STAFF REPORT
(One-Step Final Plat)

CASE NUMBER: SUB 2001-129 – SOWERS ADDITION

SUB 2001-129 – One-Step Final Plat of SOWERS ADDITION
January 3, 2002 - Page 2

VICINITY MAP

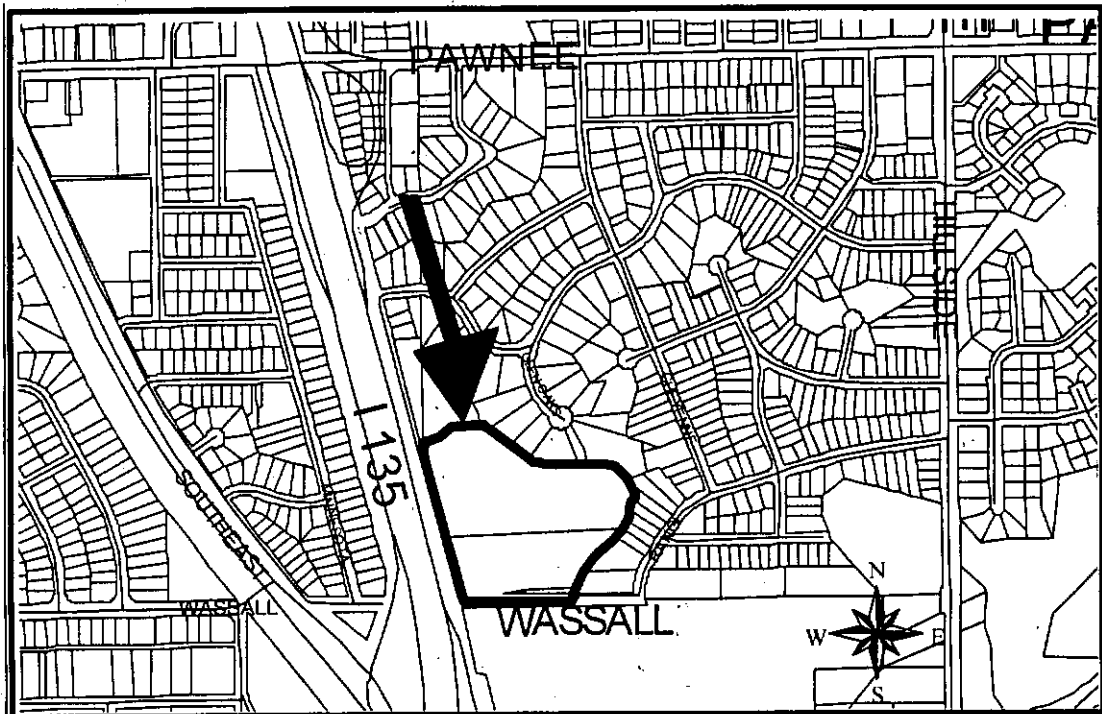
- C. City Engineering needs to comment on the status of the applicant's drainage plan and the need for any reserve areas.
- D. The 30-ft dimension along Spruce needs to be identified as half-street or full street right-of-way.

- E. The Park and Pathways Plan indicates a greenway abutting this plat. A public access easement should be platted along both south and west property lines.

- F. The width of the Wassall right-of-way needs to be denoted.
- G. The interior lot line needs to be removed.
- H. The year "2002" needs to replace "2001" within the signature blocks.
